ADDENDUM NO. 3

Price-Martin Facility Hardening

Wednesday, February 12, 2025

Passero Associates Project No. 20213160.0006

ADDENDUM NO. 3 A-102

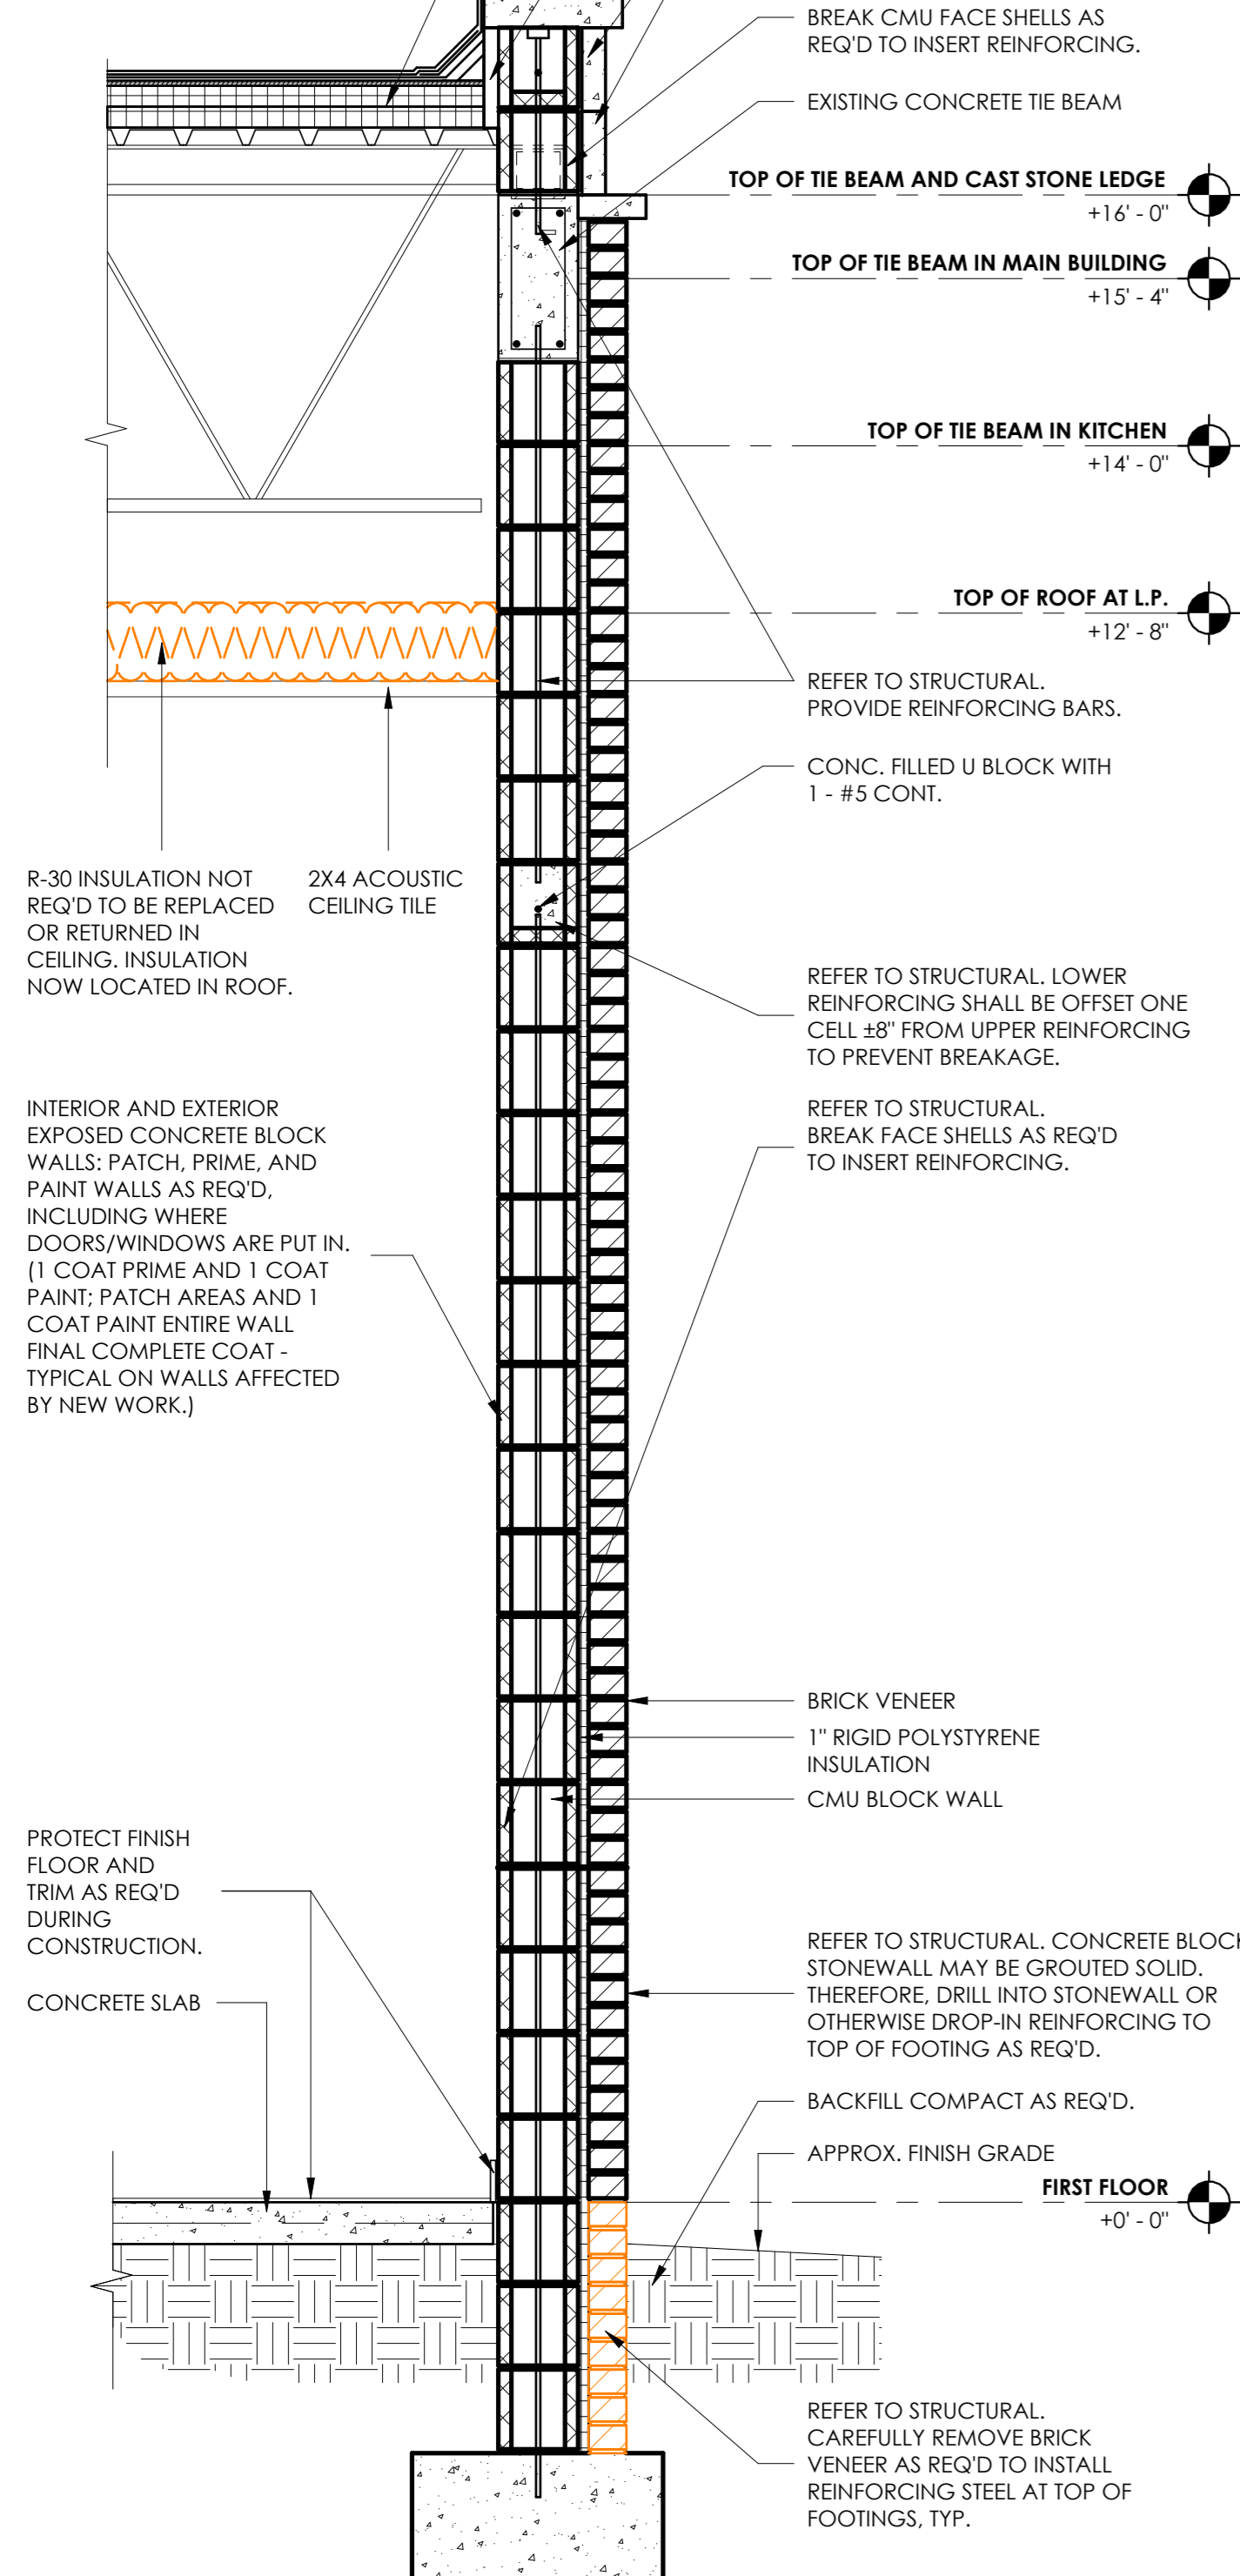
NOTE the revisions on ADDENDUM NO. 3 A-102 and ADDENDUM NO. 3 A-310 regarding the roof slope and tapered insulation detail (2/A-310).

Per 2023 Florida Building Code, Section 1511 Existing Roofing, the slope of the reroof is not required to fulfill the ¼"/12" slope requirement. Therefore, the existing slope of 1/8"/12" is to remain.
